SERVICE INSTRUCTION

RUNNING MODIFICATIONS ON

ROTAX® ENGINE TYPE 912 AND 914 (SERIES)

SI-25-1997 R9

fig. 3

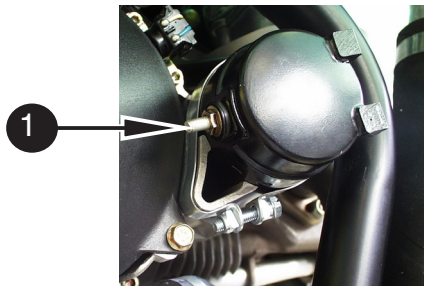
3.8) Trigger coil kit part no. 965175 is not available any longer

The trigger coil kit part no. 965175 and the trigger coil for the rev-counter part no. 264080 will no longer be supplied. For parts service the trigger coil kit part no. **965176** and rev-counter trigger coil part no. **264086** have to be ordered. Old and new version of these items are interchangeable but take note of the different trigger gap.

Trigger gap for the NEW trigger coil: **0,3 - 0,4 mm (0,012 - 0,016 in.)**

◆ NOTE: The fixation of the trigger coil is changed from cylindrical bore with centering to elongated bore. Take care of correct assembly. (see fig. 21)

fig. 4

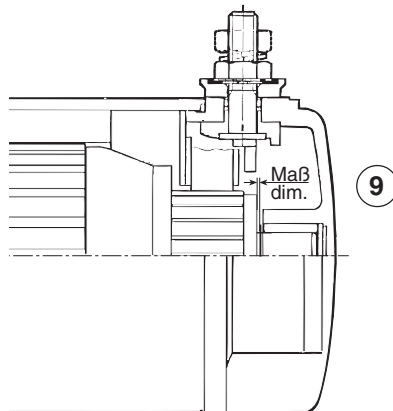
3.4) Changing of the tightening torque on the main current terminals of the starter relay and on the plus terminal of the electric starter

The tightening torque of the cable connections on starter relay part no. 992819 and on electric starter has been reduced from 8 Nm (70 in.lb) to **4 Nm** (35 in. lb). The new tightening torque must be considered at assembly of all 912 and 914 engines.

Furthermore, if using the ROTAX[®] engine suspension frame, the fitting position of the electric starter is limited to only one position instead of formerly two positions, as otherwise the terminal (1) would collide with the engine frame.

fig. 5

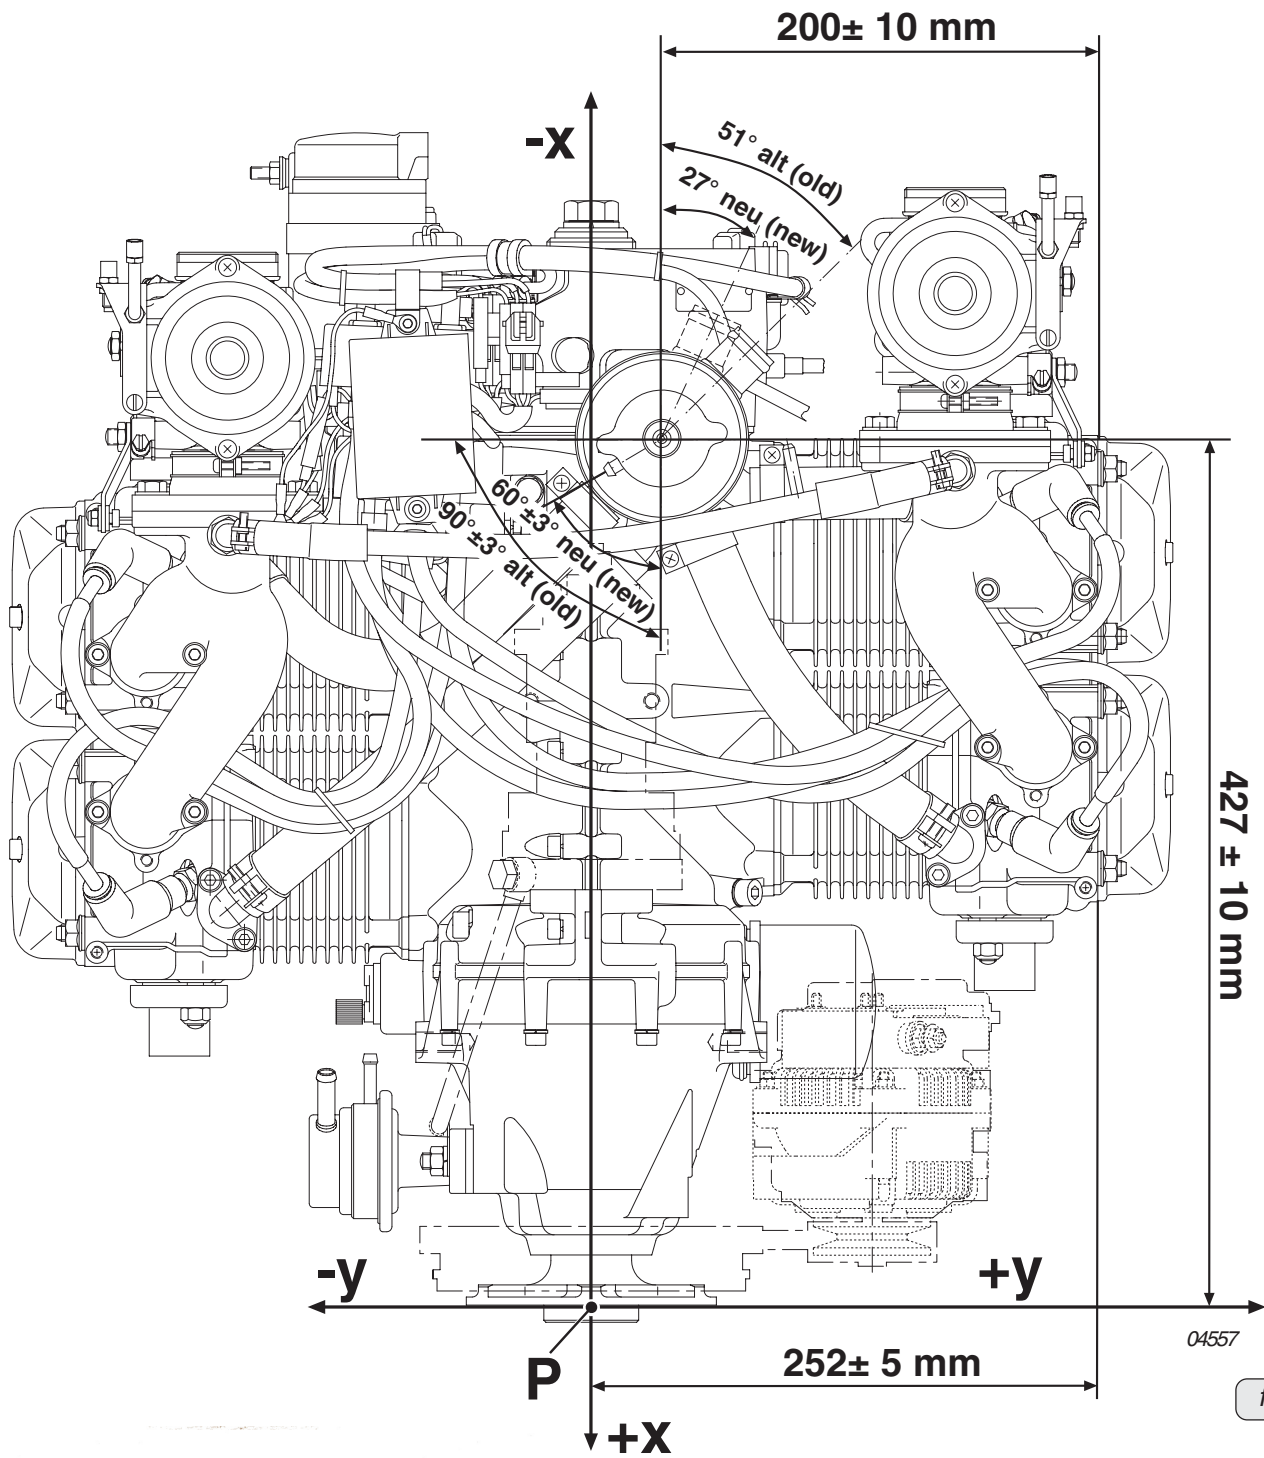
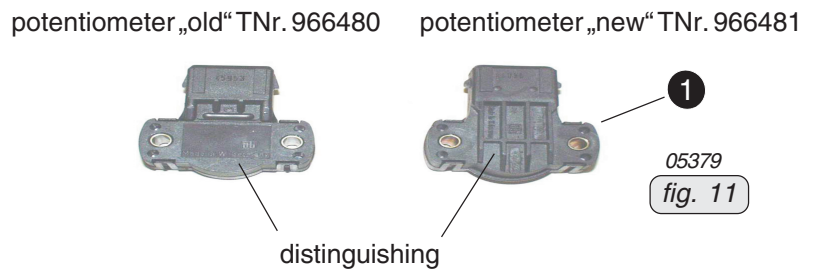
3.11) Introduction of a new expansion tank assy.

In the course of further development and standardization the position of the expansion tank (1) has been optimized!

- position of connection (2) to overflow bottle (from 0° to 30±3°)
- position of connection (3) to radiator (from 51° to 27±3°)
- angle of inlet socket (4) from cylinder 4 (34° inclined)
- length of inlet socket (5) from cylinder 3 (length increased by 13,4±3 mm)
- length of coolant hose (6) from cylinder 1 (length increased from 270 mm to 285 mm)
- length of coolant hose (7) from cylinder 4 (shortened from 100 mm to 85 mm)
- new spring type hose clamps (8) to attach the coolant hoses (expansion tank and water pump)

fig. 7

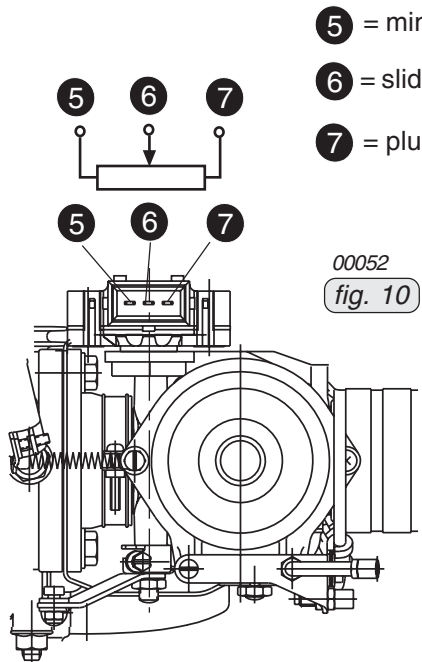
¹⁾ e.g. HAZET®, BERNER® or equivalent. See fig. 7.

- Inspect the rubber plate (10).
- ◆ **NOTE:** Wear of up to 1 mm from original thickness can be tolerated!
- Install the coolant hose (6) 285 mm to cylinder 1 and the new coolant hose (7) 85 mm to cylinder 4. For attaching all the coolant hoses from expansion tank, water pump, cylinders, use the new spring type clamps.
- **ATTENTION:** Take care of appropriate slip-on length of the coolant hoses on the corresponding connection socket. Verify tight fit of clamps and hoses and check for leakage. Always fit the clamps such that they can not wear on any component and use a suitable tool (see fig. 7) for fitting them.

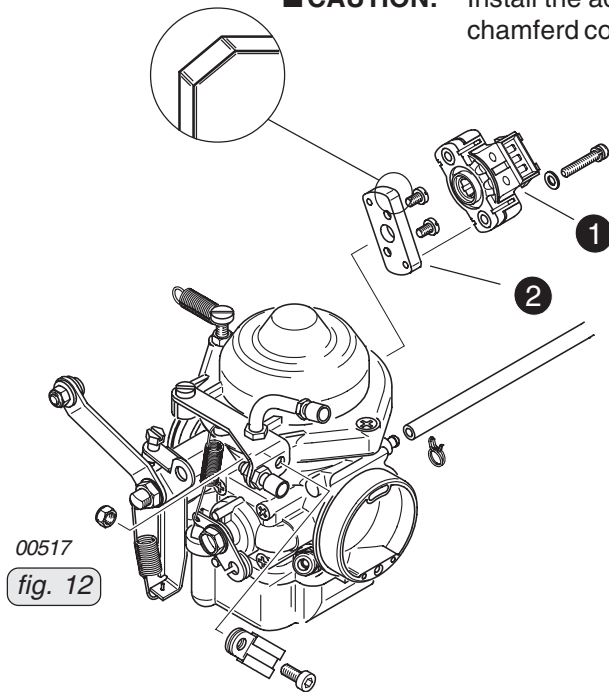
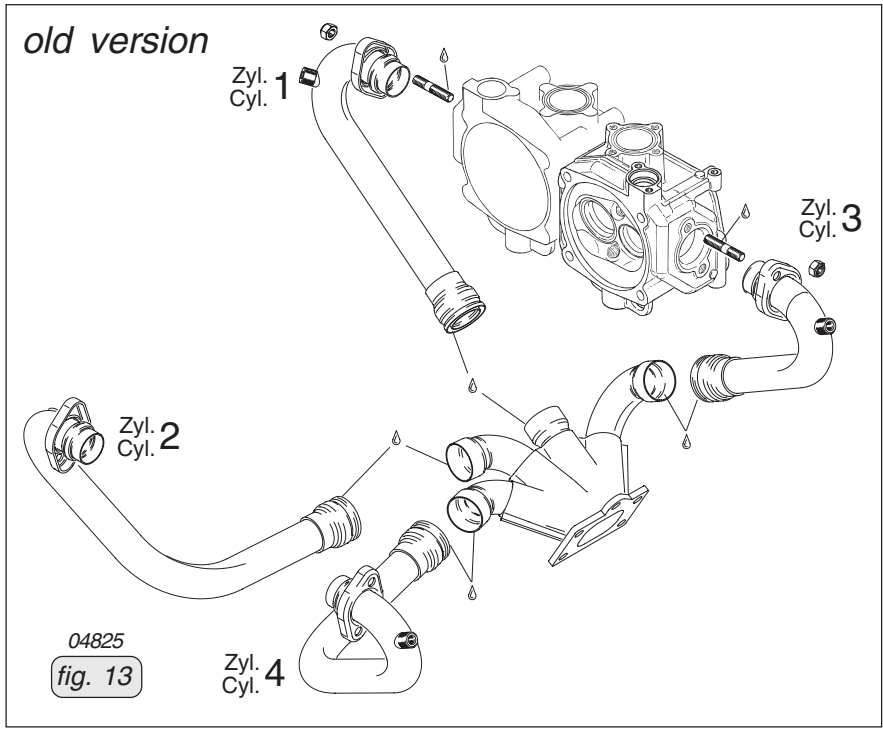
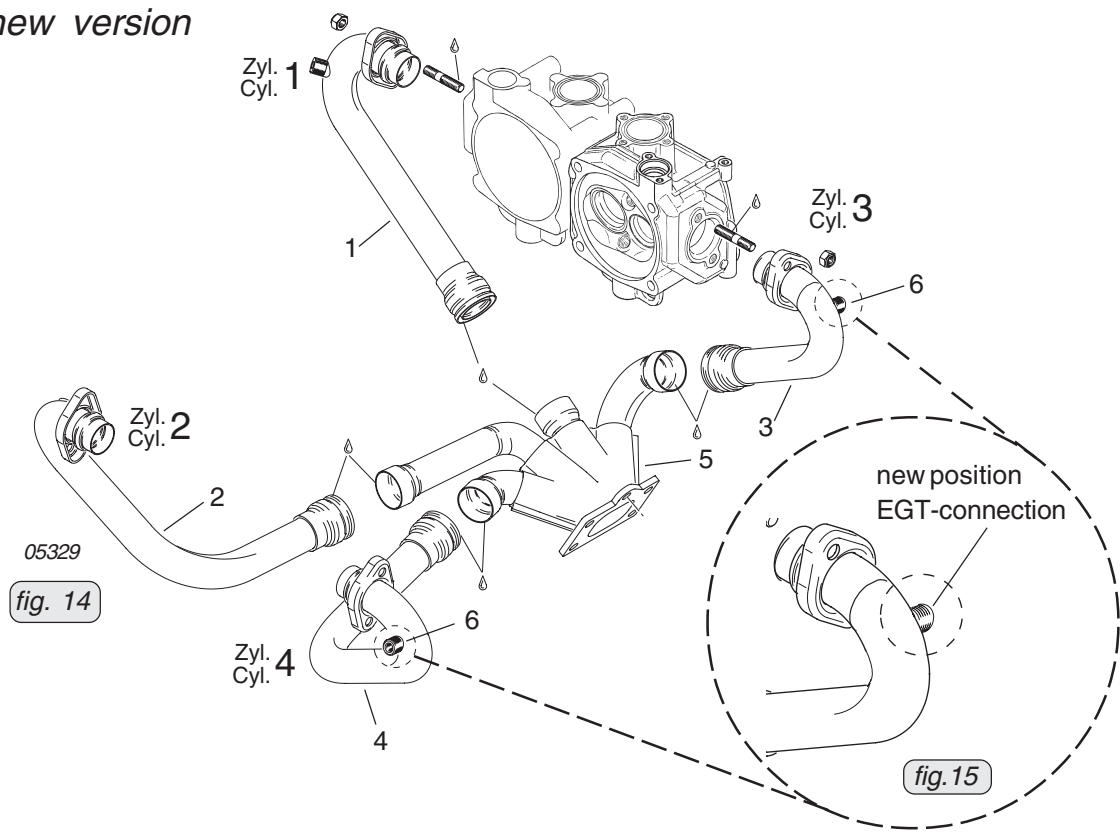
3.13) Introduction of a new throttle potentiometer for ROTAX® engine type 914

Owing to continuous further development and standardization, a new throttle potentiometer part no. 966481 (1) has been introduced.

- New adapter flange (2) for attachment of the new throttle potentiometer.

Resistance between the terminals (5) and (6):(see fig. 10)

Throttle **open** (throttle lever pos. 115%): value must be less than 3,8 kΩ .

Throttle **closed** (throttle lever pos. 0%): value must be more than 100 Ω.

CAUTION: Install the adapter flange with the position chamferd corner up side.

05735
fig. 16

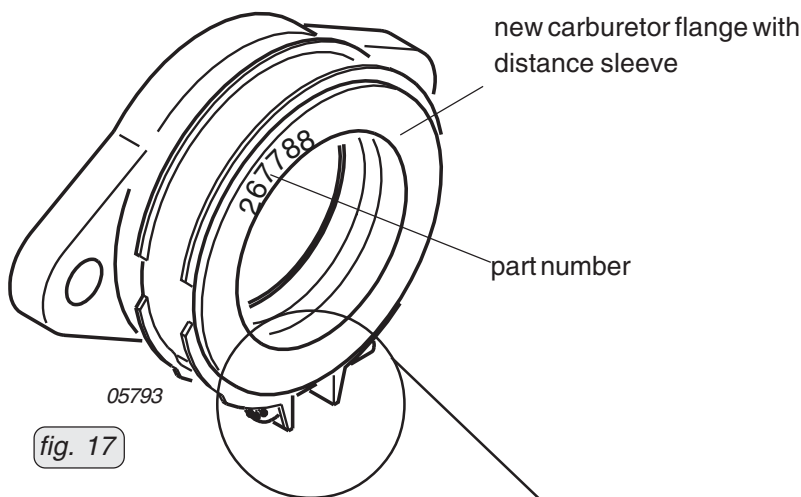
3.15) Introduction of new radiator cap

Owing to continuous further development and standardization in other engines the radiator cap with higher 1,2 bar (18 psi) opening pressure have been introduced.

05793
fig. 17

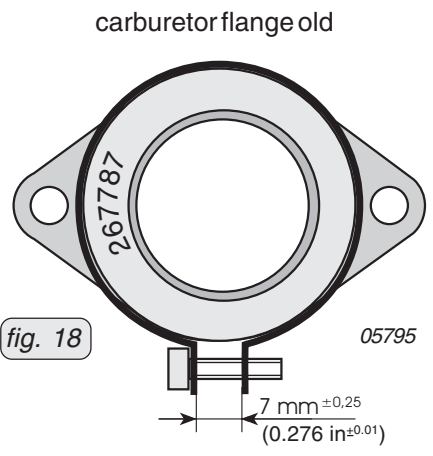
3.16) Introduction of new carburetor flange

Owing to continuous further development and standardization in other engines the carburetor flange part no. 267788 introduced.

■ **CAUTION:** Due to differences in spacing **don't use** the distance sleeve (1) included in delivery of the carburetor flange part no. 267788 in combination with the carburetor flange part no. 267787.

fig. 18 05795

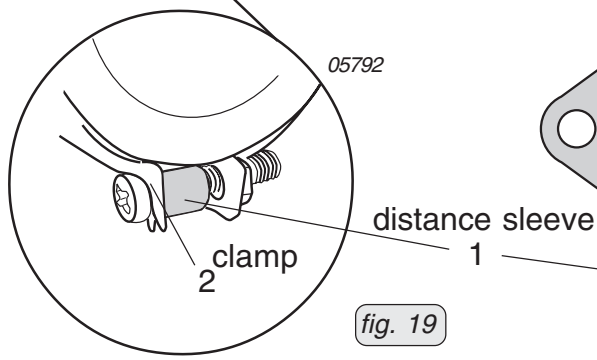
■ **CAUTION:** **Don't use** aluminum insert included in delivery of the carburetor flange part no. 267785 or 267780 in combination with the carburetor flange part no. 267788.

fig. 19

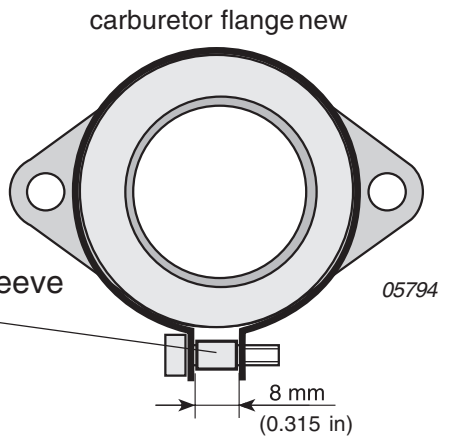
- At exchange, take care of the following:
- If replacement of part no. 267788 is necessary **both** carburetor flange are to be replaced per engine. (Do not mix new style with old style on the same engine)
- Tighten clamp (2) of the carburetor flange part no. 267788 with tightening torque 2.5 Nm (22 in.lb) (see fig. 19) .

fig. 20 07138

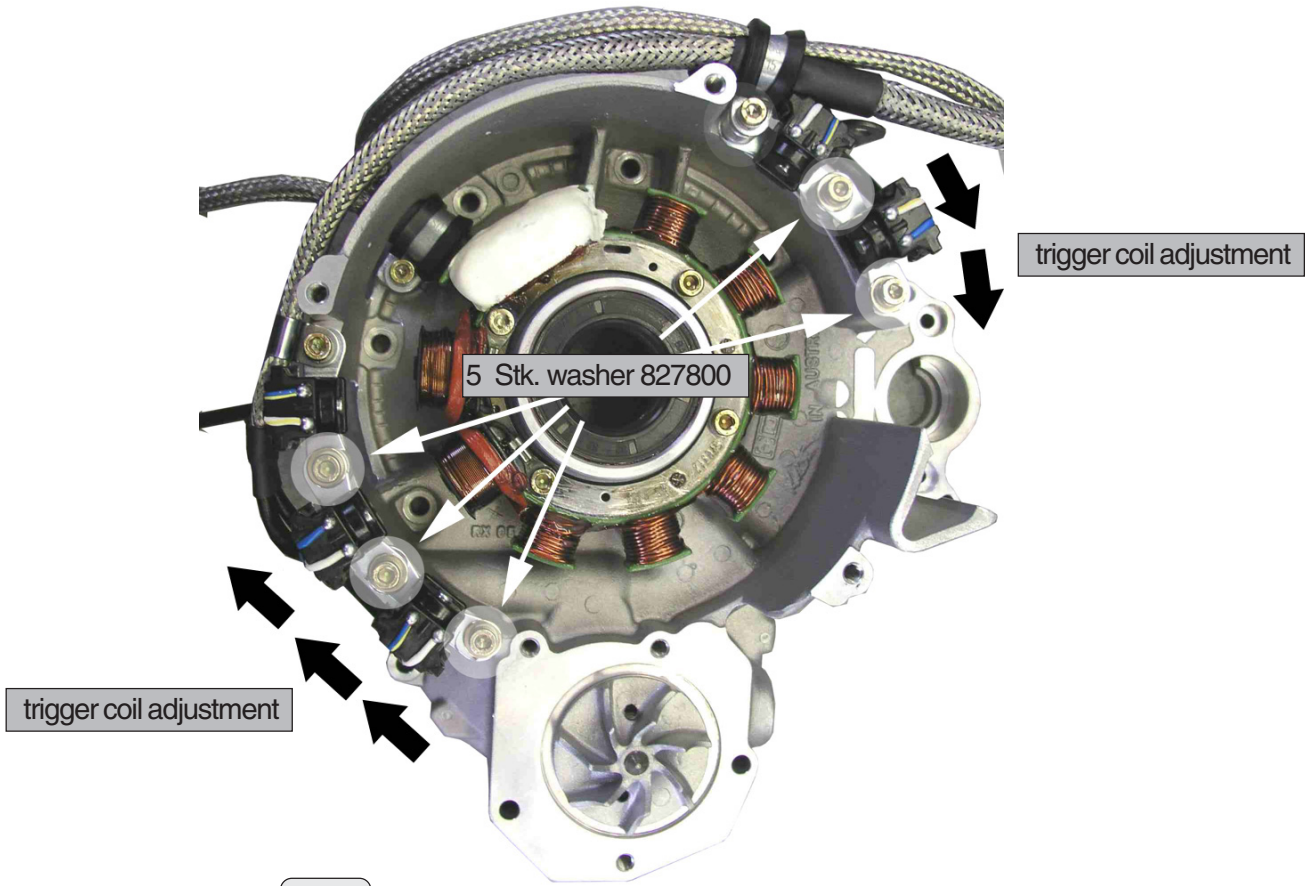
3.17) Introduction of a new trigger coil part no. 264086 and trigger coil kit part no. 965179

- The cylindrical fixation bore with centering are now carried out as elongated bore (fig. 20).
- 5 additional washers are necessary for fixation.

fig. 21

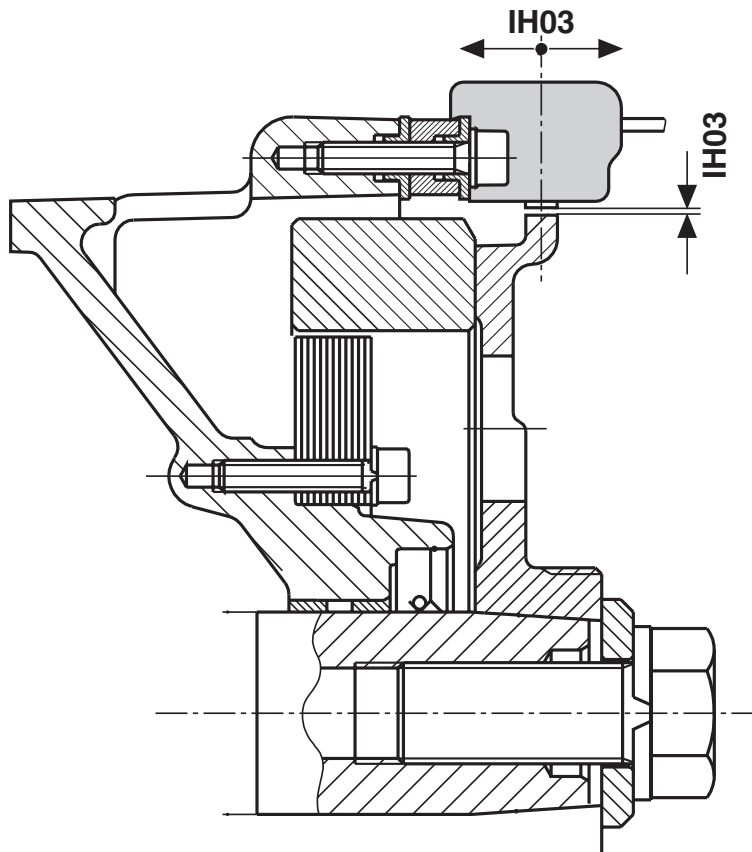
■ CAUTION: Because of no centering of the new trigger coil and clearance between screw and elongated bore, all trigger coils have to be pushed clockwise on block during adjustment of the trigger coil gap (see fig. 21).
